Access Compliance Report Public Rights-of-Way (Curb Ramps)

Intersection ID: 25446 Main Street: ARCHGATE_CT Cross Street: SOUTHBRIDGE_FOREST_DR Location: NE

ADA ID: 3514700C4E9C Ramp Type: PerpDiag Initial Pass/Fail: Fail Overall Compliance: No Severity Score: 13.75

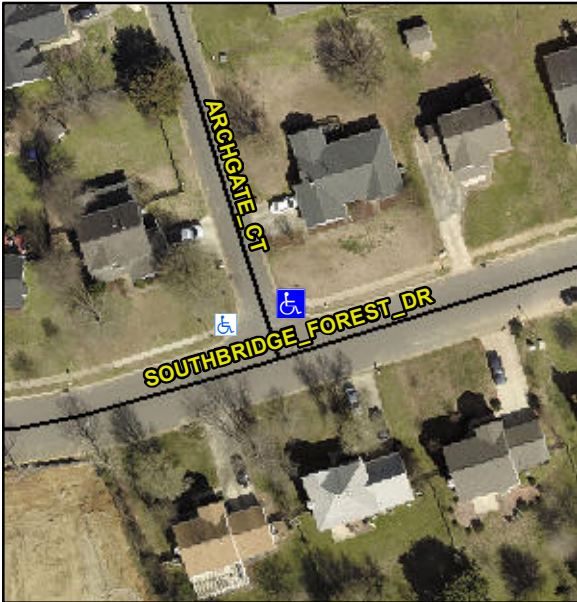
PROW/ADA:
R304.2.2, R304.5.3

Compliance	Description	Data	Compliance	Description	Data
N/A	Ramp Length (in)	46.5	No	Ramp Slope (%)	10.2
Yes	Ramp Width (in)	48.0	No	Ramp XSlope (%)	2.2
N/A	Flare Type LT	N/A	N/A	Flare Type RT	N/A
N/A	Flare Slope LT (%)	N/A	N/A	Flare Slope RT (%)	N/A
N/A	Flare Traversable LT?	N/A	N/A	Flare Traversable RT?	N/A
N/A	Landing Length (in)	N/A	N/A	DWS Provided?	N/A
N/A	Landing Width (in)	N/A	N/A	DWS Contrast?	N/A
N/A	Landing Slope (%)	N/A	N/A	DWS Length (in)	N/A
N/A	Landing X Slope (%)	N/A	N/A	DWS Full Width?	N/A
N/A	Landing Curb? (Y/N)	N/A	N/A	DWS Offset (in)	N/A
N/A	Shared Landing?	N/A			
N/A	Gutter Ponding?	N/A	N/A	Gutter Slope (%)	N/A
N/A	Gutter Lip Ht (in)	N/A	N/A	Gutter X Slope (%)	N/A
N/A	Painted X Walk1?	No	N/A	Painted X Walk2?	No
	X Walk 1 Direction	To W		X Walk 2 Direction	To S
N/A	X Walk 1 Width (in)	N/A	N/A	X Walk 2 Width (in)	N/A
	X Walk 1 Slope (%)	0.4		X Walk 2 Slope (%)	2.5
	X Walk 1 X Slope (%)	1.6		X Walk 2 X Slope (%)	3.4

Possible Solutions:
Remove & Replace Curb Ramp With Two New Directional Ramps or Equivalent.
